## M24C64X-FCU and M24C64X-FCP read operations on chip enable register update

### Silicon identification

This errata sheet applies to M24C64X-FCU and M24C64X-FCP, 64-Kbit serial I<sup>2</sup>C bus EEPROMs, with configurable device address and software write protection, delivered in 4-ball CSP.

**Figure 1. Old figure**

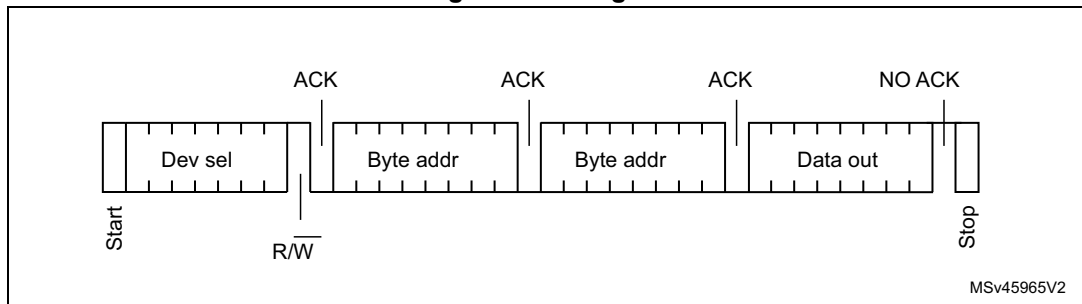
The figure must be modified as a standard random address read from:
